78. Energy-Efficient Ethernet (EEE)

Add the following text to Clause 146 (and renumber the following chapters):

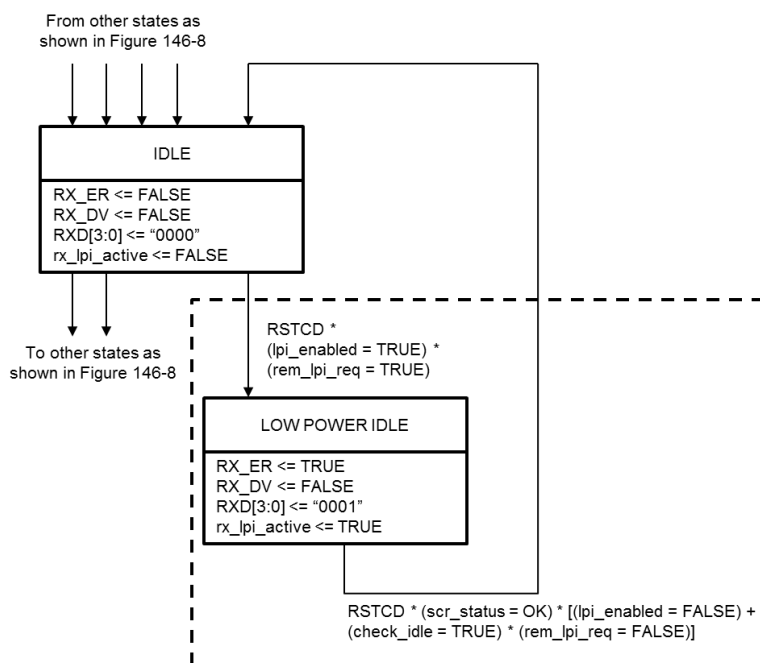
Add the following LOW POWER IDLE state to Figure 146-8 (PCS receive state diagram):

Add "rx_lpi_active <= FALSE" to state IDLE of Figure 146-8 (see above drawing).

Add a note to Figure 146-8:

NOTE—States shown within dashed line area optional.

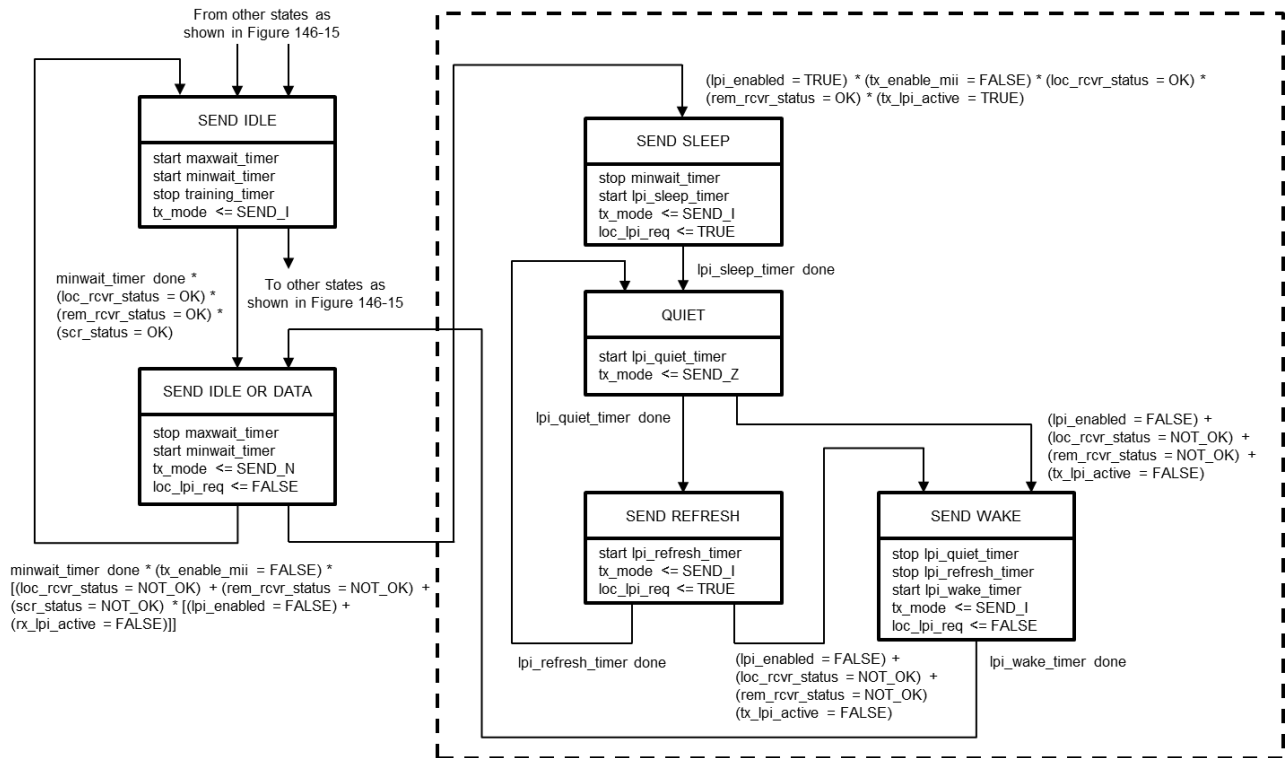
Modify state machine in Figure 146-15 (PMA PHY Control state diagram) in the following way:

Add “loc_lpi_req <= FALSE” to state SEND IDLE or DATA of Figure 146-15 (see above drawing).

Add a note to Figure 146-15:

NOTE—States shown within dashed line area optional.

lpi_sleep_timer: A timer used to determine how long the SLEEP signal (IDLE symbols with loc_lpi_req set) is being sent, before the transmitter of the local PHY goes to sleep. The timer shall expire 205 μ s \pm 5 μ s after being started.

lpi_quiet_timer: A timer used to determine how long the transmitter of the local PHY stays in QUIET mode, before a REFRESH is performed. The timer shall expire 2050 μ s \pm 50 μ s after being started.

lpi_refresh_timer: A timer used to determine how long the REFRESH signal is being sent to the remote PHY. The timer shall expire 205 μ s \pm 5 μ s after being started.

lpi_wake_timer: A timer used to determine how long the WAKE signal is being sent to the remote PHY. The timer shall expire 205 μ s \pm 5 μ s after being started.
